# **PD Modification Application:** PRS 25-1373

**BOCC Land Use Meeting Date:** November 12, 2025

The applicant is requesting a minor modification to modify the single-family detached development standards and make changes to conditions pertaining to Transportation.

#### AGENCY REVIEW COMMENT SHEET

# 2.3 Approved Site Plan (partial provided below for size and orientation purposes. See Section 8.1 for full site plan)

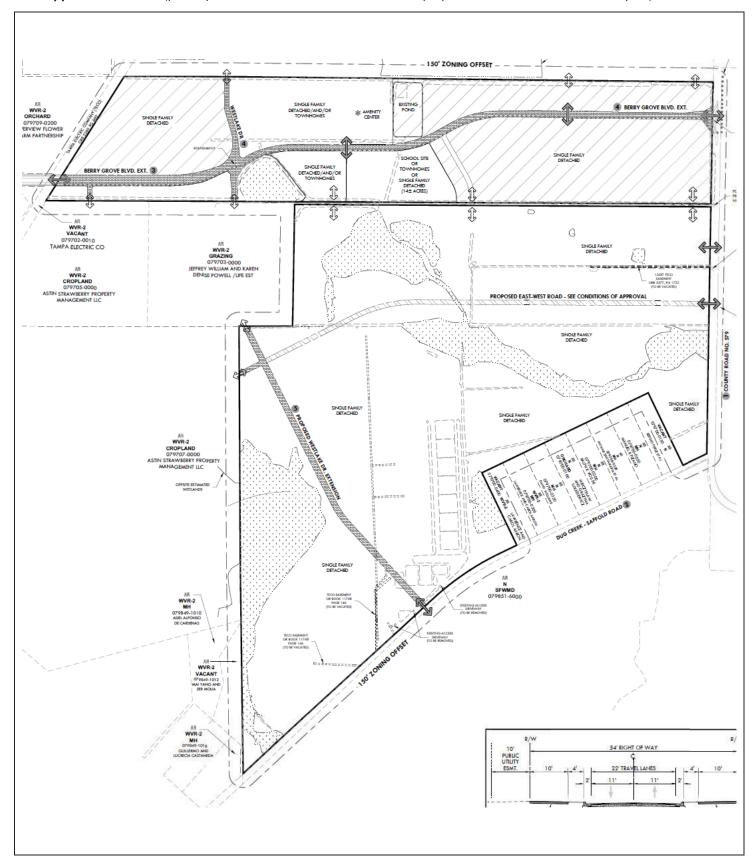
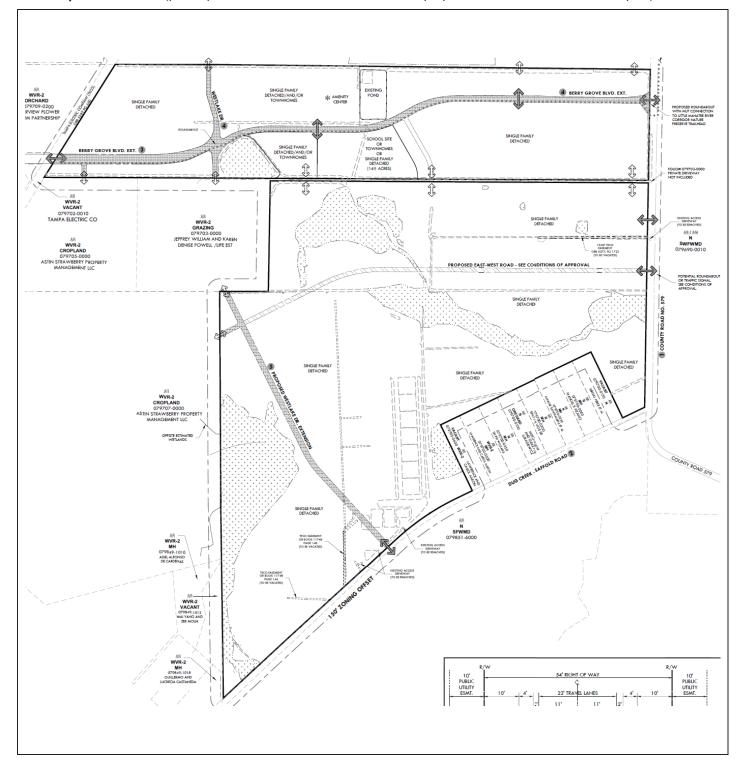
Existing Approval(s):	Proposed Modification(s):	
- Single-Family Detached Development Standards	- Single-Family Detached Development Standards	
<ul> <li>Garages shall be setback a minimum 25'</li> </ul>	<ul> <li>Garages shall be setback a minimum 20'</li> </ul>	
○ Rear yard setback – 15′	<ul> <li>Rear yard setback – 10'</li> </ul>

On the previously approved site plan, a hatched area was delineated on portions of the project site indicating homes that were to be built to the previously approved development standards. These standards were subject to the WVR-2 Residential requirements. Since the Comprehensive Plan Amendment changing the future land use from WVR-2 to RES-4, the applicant no longer wishes to keep these development standards and looks to build all homes under the newly proposed development standards for the project and has removed the hatched areas from the site plan.

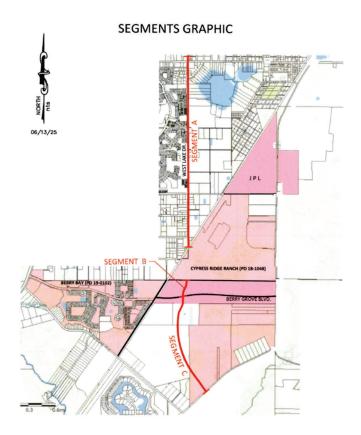
Improvements to W. Lake Dr. have been broken into three (3) segments. Segments A is defined as the section of W. Lake Dr. between Bishop Rd. and the northern property boundary of the Cypress Ridge Development (i.e. adjacent PRS 24-1033). Segment B is defined as that portion of W. Lake Dr. between the southern property boundary of the Cypress Ridge Development (i.e. the northern boundary of the subject PD) and Berry Grove Blvd. Segment C is defined at that portion of W. Lake Dr. between Berry Grove Blvd. and Saffold Rd.

Given the above, the applicant's Engineer of Record (EOR) submitted a Design Exception request as a part of the 25-0371 application (dated June 13, 2025) for W. Lake Dr. to determine the specific

improvements that would be required by the County Engineer. Based on factors presented in the Design Exception request, the County Engineer found the request approvable (on July 11, 2025), and ultimately approved the request (on October 25, 2025).

### 3. Within Segment C:

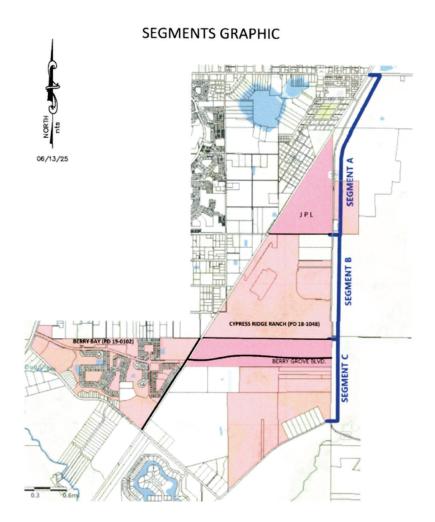
- a. The developer will be permitted to maintain the 10-foot-wide lanes in lieu of the 12-foot-wide lanes required pursuant to the Typical Section 7 (TS-7) of the Transportation Technical Manual (TTM);

- b. The developer shall dedicate and convey to Hillsborough County sufficient right-ofway to accommodate proposed improvements (a minimum of 48-feet east of the existing centerline). Staff notes this is in addition to any right-of-way necessary to accommodate site access improvements or additional preservation required pursuant to the Hillsborough County Corridor Preservation Plan as further described herein;

### 1. Within Segment B:

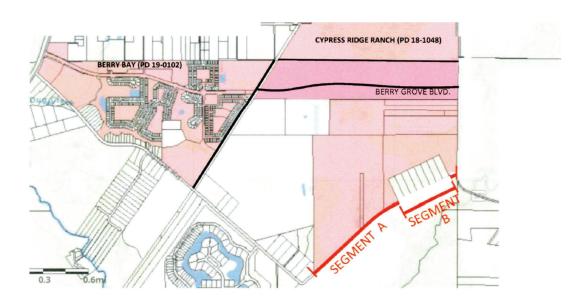
- a. The developer will be permitted to maintain the 10-foot-wide lanes in lieu of the 12-foot-wide lanes required pursuant to the Typical Section 7 (TS-7) of the Transportation Technical Manual (TTM);
- b. The developer will be permitted to construct 6-foot-wide stabilized shoulders along both sides of the roadway, in lieu of the 8-foot-wide stabilized shoulders of which 5-feet is paved along both sides of the roadway as required pursuant to TS-7 of the TTM, thereby eliminating required bicycle facilities within this segment; and,
- c. The developer will be required to construct a 5-foot-wide sidewalk along the north side of the roadway.
